Steepbank Mine Project

Supplemental Information Response

**SUPPLEMENTAL INFORMATION RESPONSE
STEEPBANK MINE PROJECT
EUB APPLICATION NO. 960439
AEP APPLICATION NO. 020-95, AND FILE NO. 27551**

The following information is provided in response to the Energy and Utilities Board and Alberta Environmental Protection supplemental information request dated July 12, 1996. The following response follows the outline of your supplemental request letter.

Figure 5.8-1

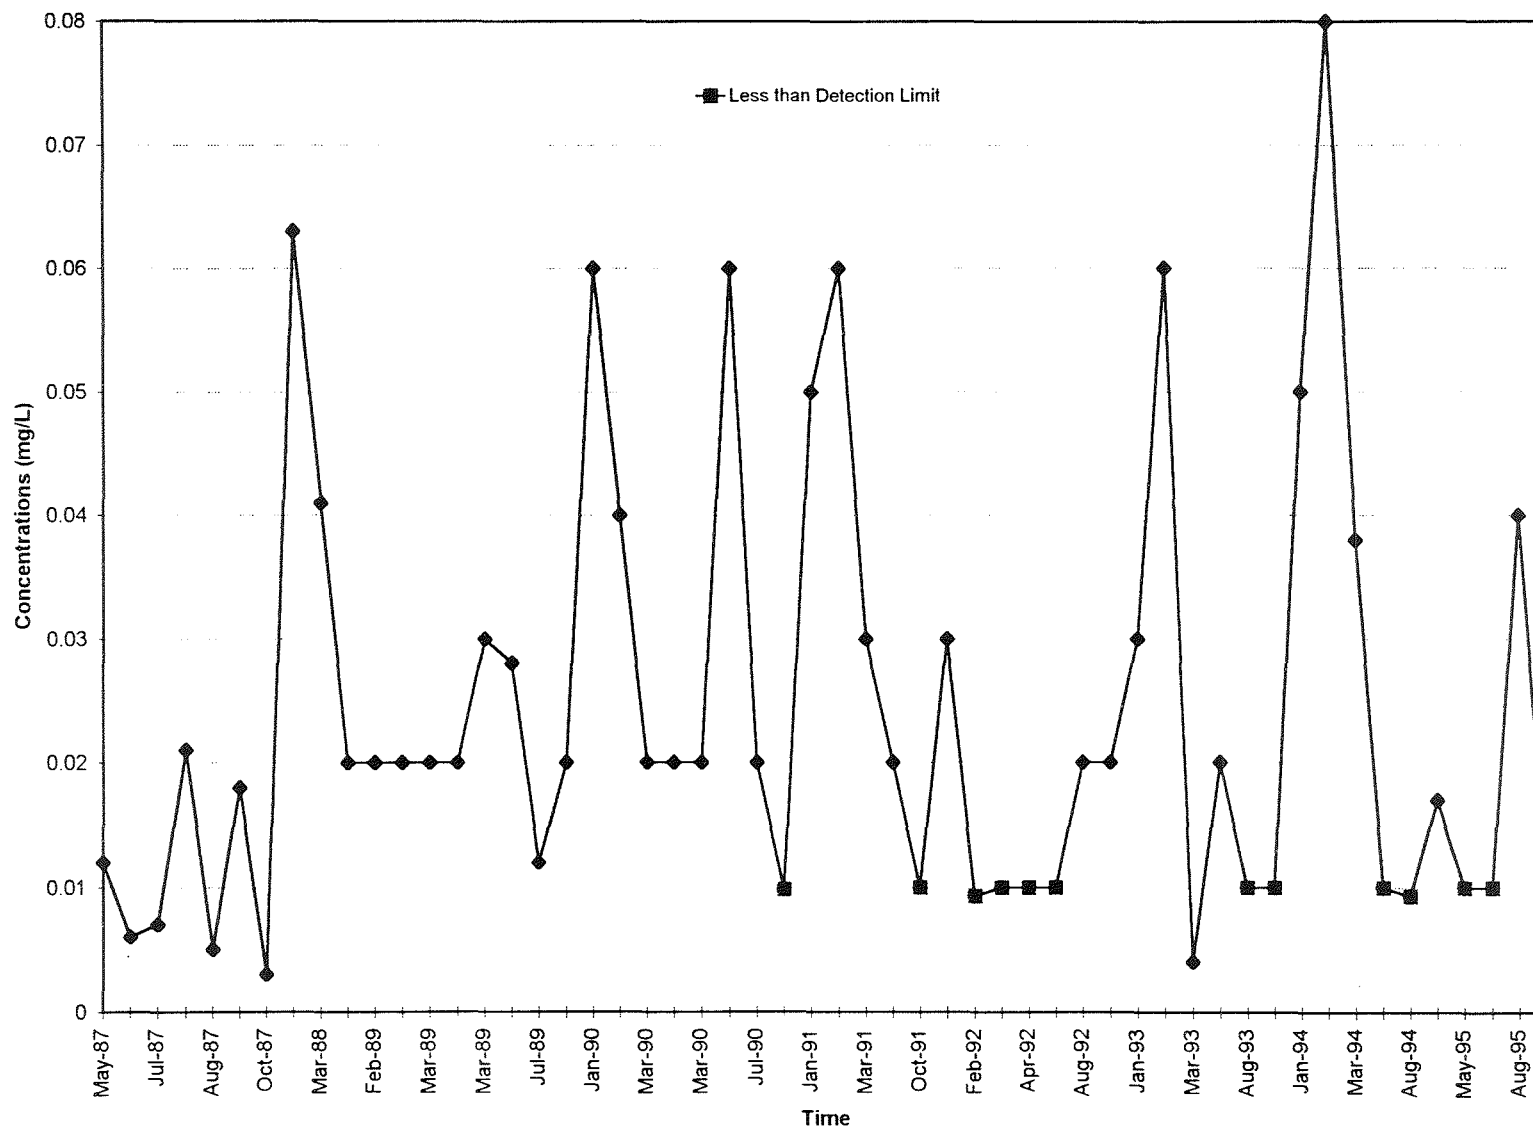
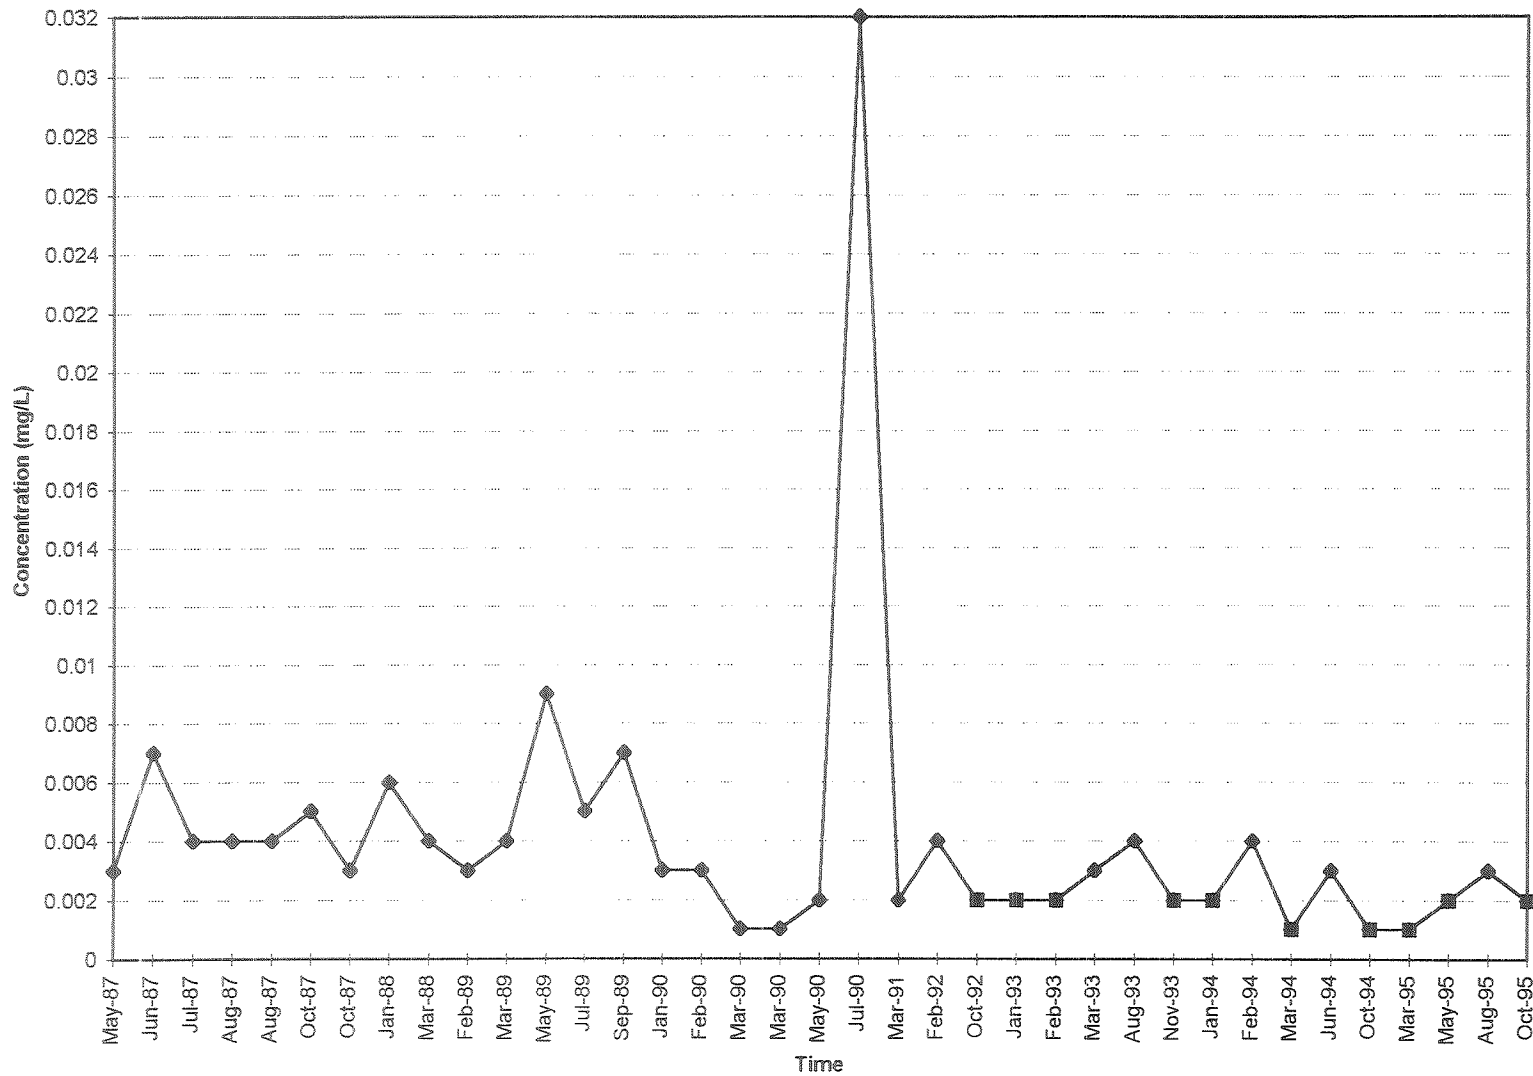
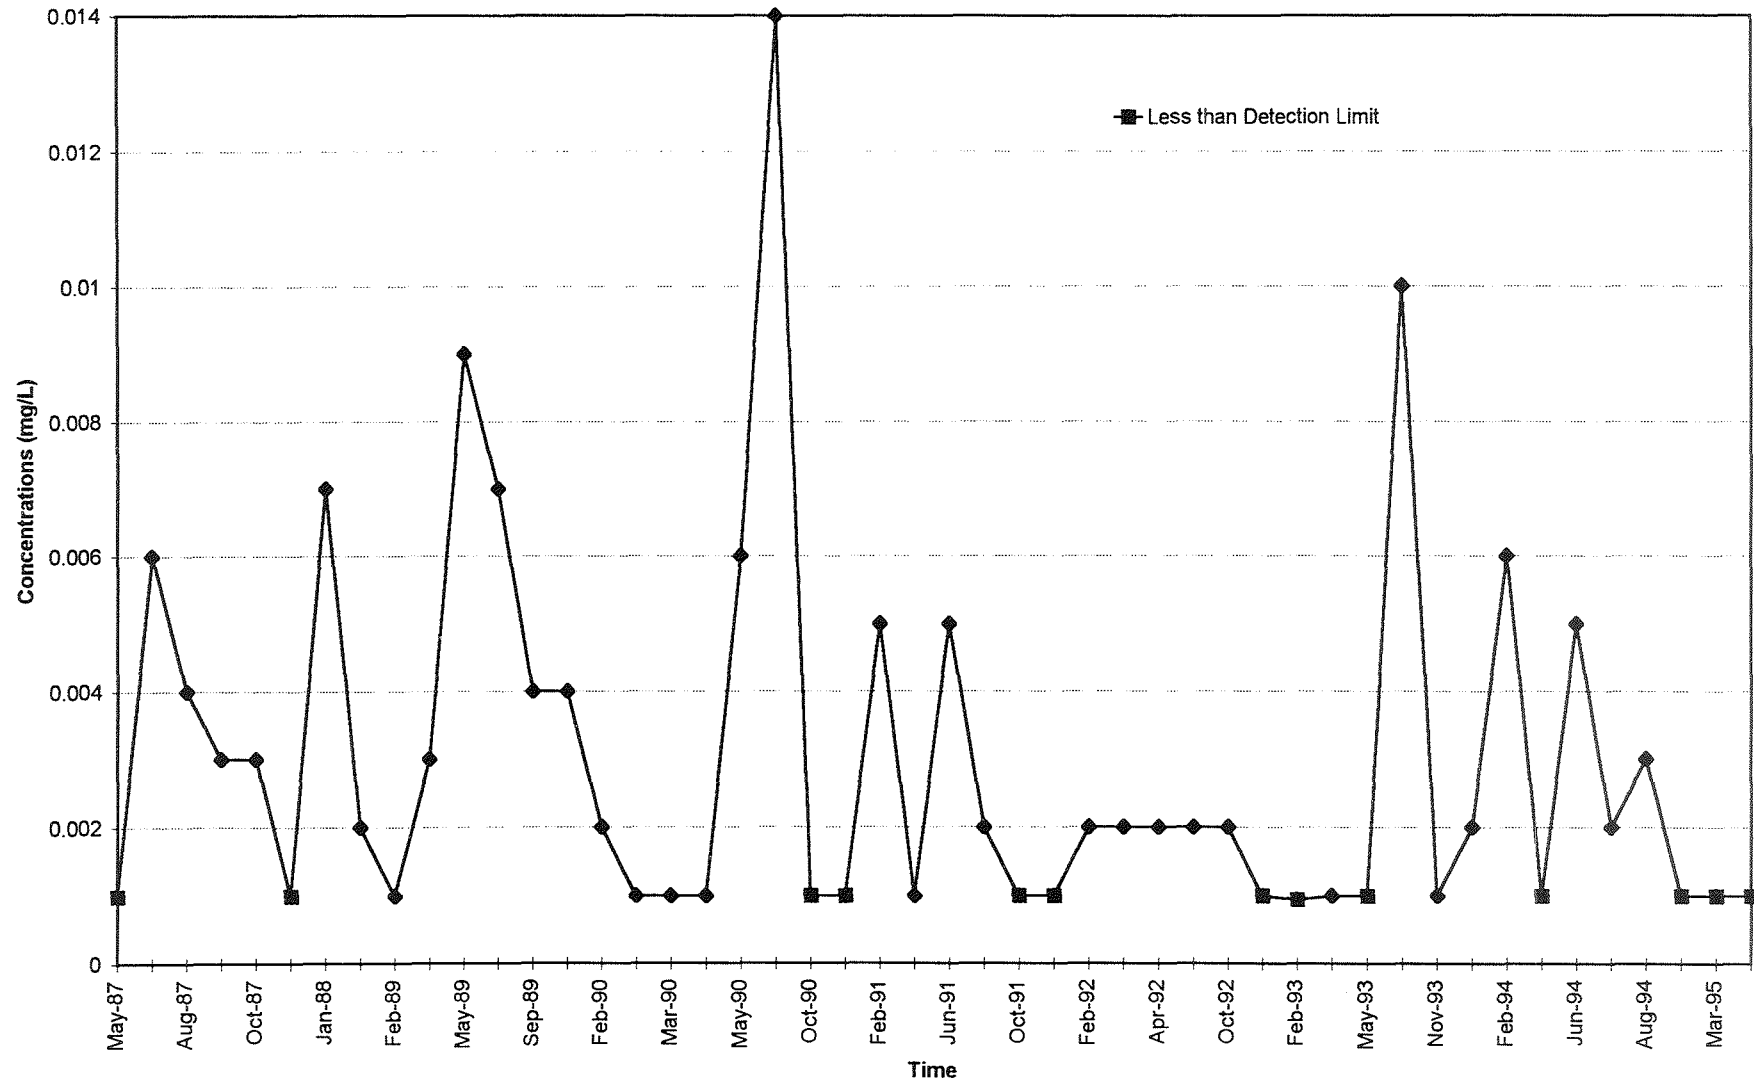
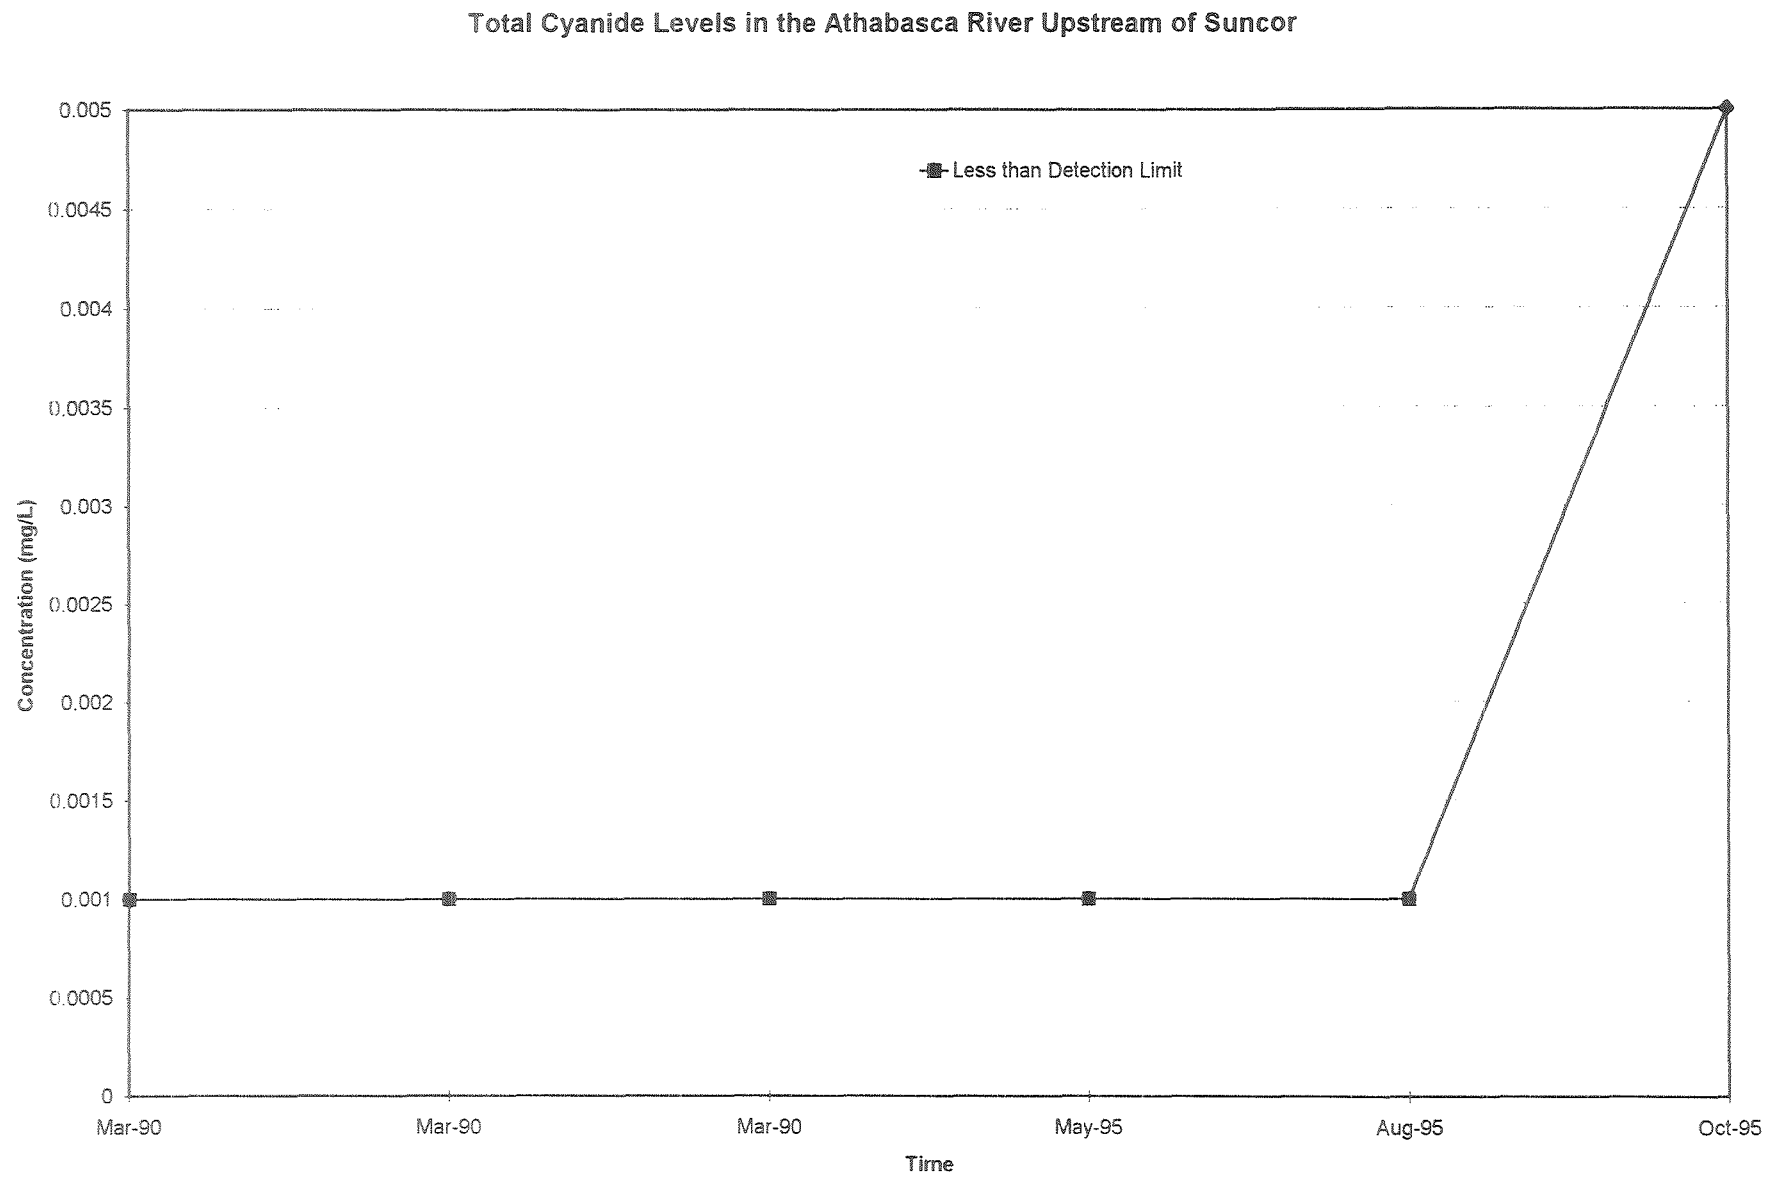
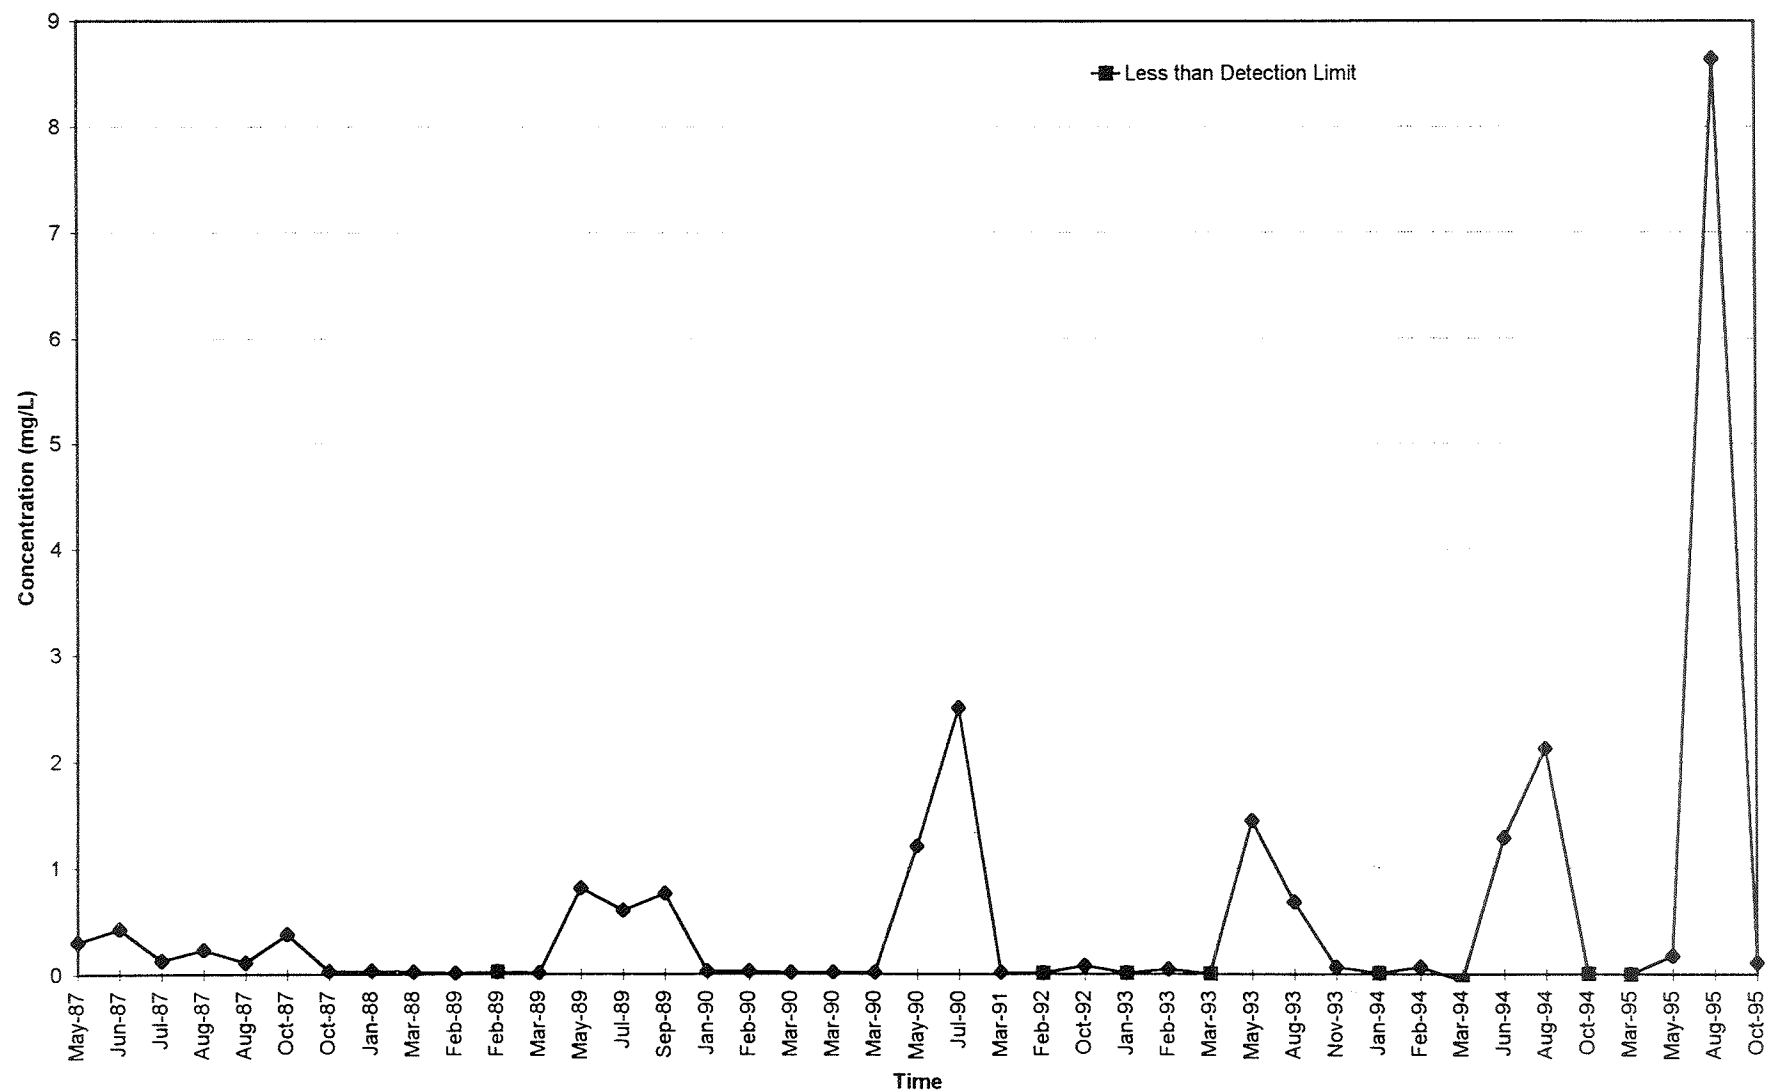
Q5.8 Provide time series graphs for each of the background river substances that indicated potential to exceed in-stream guidelines, either naturally, or as a result of Suncor's discharges (*Athabasca River Water Releases Impact Assessment, May 1996*).
